Re: Edgar P. Mills Multi-Purpose Center – Parking Garage
Broward County, Florida

NOTICE OF CLAIM PURSUANT TO CHAPTER 558, FLORIDA STATUTES

Re – Edgar Mills Complex – Parking Garage, 900 NW 31st Avenue, Fort Lauderdale, FL:

Observed crack at a second-floor joist support – Field Report:

Exhibit 1: Cracked Haunch below third floor joist.

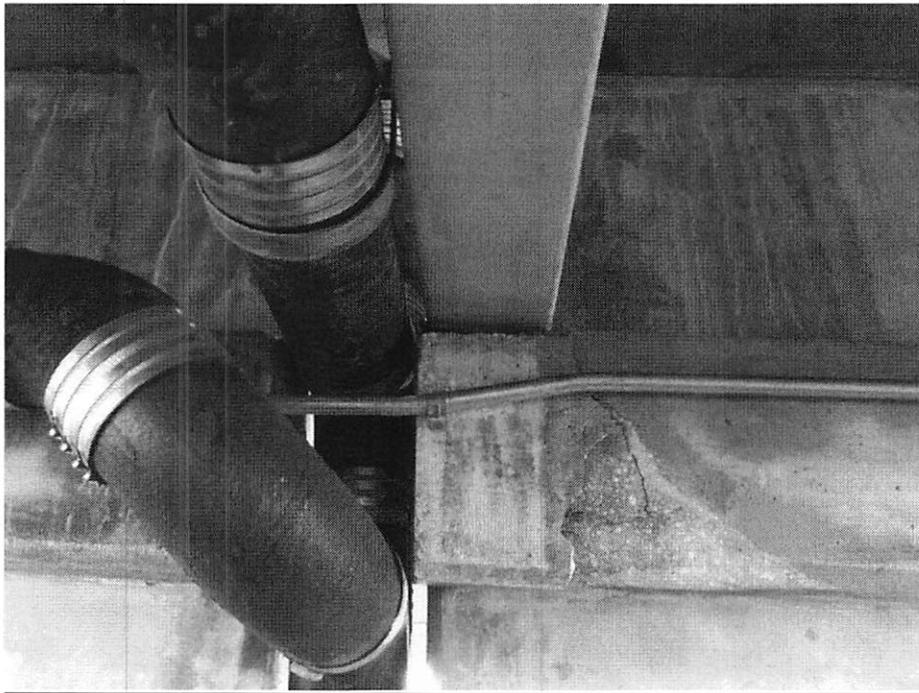
- 2) Second-Floor Haunch Crack: Below the West end of a third-floor joist (8th joist counting from the South Entrance) on the East wing of the garage, supporting haunch has failed as shown in the attached exhibits 1 through 4. Currently only the back end of the haunch may be providing any support to this joist. There is no bearing of the joist toward the face of the haunch as shown on exhibits 10 and 11. This joist is currently supported with temporary shoring extending to the ground floor slab as shown on exhibits 4 to 8. The Garage is currently closed, and no vehicles are parked inside.

The failed third floor haunch is at the edge of a concrete wall panel. We can see that the longitudinal rebar and the stirrups are located too far inside the haunch, with about 3" concrete cover. It is important to locate the reinforcing close to the face of the haunch to prevent the unreinforced concrete along the edges to fail in shear. This is exacerbated by the fact that at this location, the joist is supported at the end of the haunch. This creates a situation where the haunch is in single shear versus the typical condition of double shear, essentially reducing the shear capacity by half. We believe that these are the possible causes for the shear failure observed.

We believe that the installed shoring below the third-floor joist, continuous to the ground floor is adequate to temporarily support this joist at the cracked haunch. We recommend similar shoring at a similar condition which is occurring on the second joist to the North of the cracked haunch as shown on exhibit 9.

Exhibit 12: Spalled face of a haunch below a supported joist.

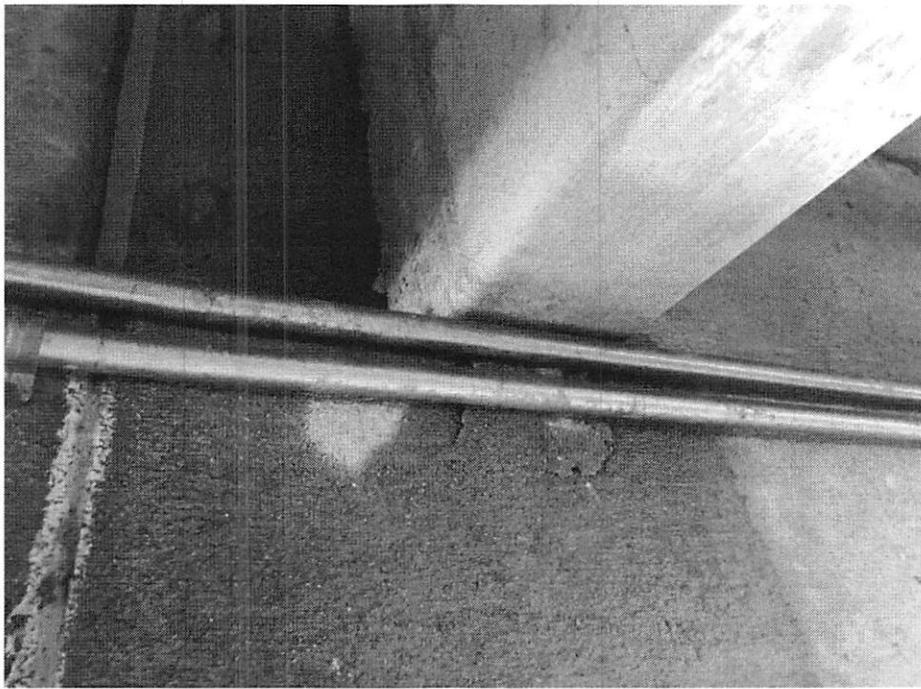
- 3) Cracks and Spalls on the face of haunches at other locations: We observed cracks and spalling on the face of haunches at other locations as shown on exhibits 12 to 14. These are occurring primarily below the roof joists.

We believe that the relatively smaller spalling and cracking at the faces of the haunches at other locations are due to the flexing of the joists up and down due to the temperature variations which are more severe for the joists below the exposed roof slabs.

We believe that the garage can be opened after installing this shoring and protective barricade around the shoring. This shall be followed by a complete review of the structural drawings and permanent repairs of the observed spalling and cracking at the haunches, soffit beams and slabs.

Exhibit 16: Spalling and Cracking on a soffit beam at a joist support.

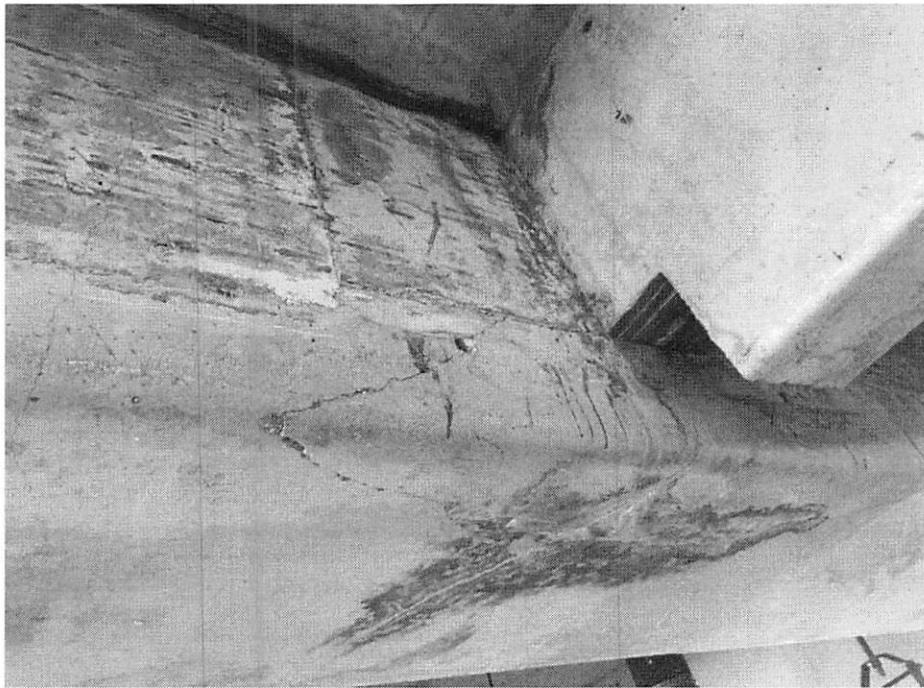
- 4) Cracks on Soffit Beams: Cracks are found on the soffit beams at the North end and South end as shown in the exhibits 15 to 17. Cracks are vertical cracks and diagonal cracks and also cracking below supported joists.

We believe that the soffit beam cracks below the supported joists are due to the flexing of the joists up and down due to the temperature variations which are more severe for the joists below the exposed roof slabs. Other vertical and diagonal cracks appear to be stress cracks due to the applied loading.

Exhibit 19: Slab cracks along the sides of a soffit beam.

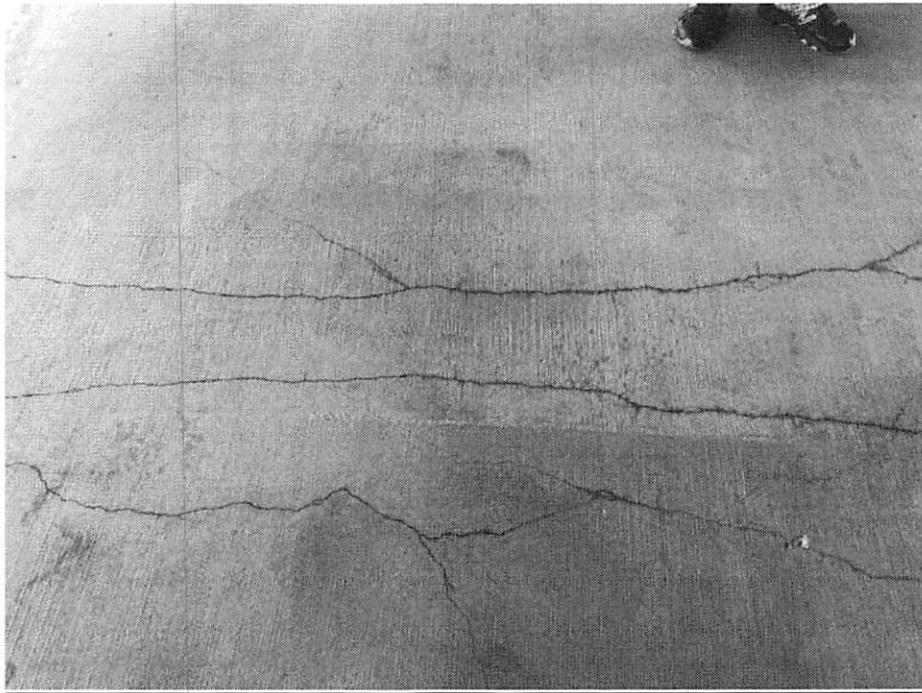
- 5) Concrete Slab Cracks: There are widespread cracking on concrete slab. Cracks are also noted along the top of soffit beams as shown on exhibits 18 to 20.

Topping slab has widespread cracks as noted above. It appears that these are primarily shrinkage cracks. We also observed cracks due to negative moments along the top of soffit beams.
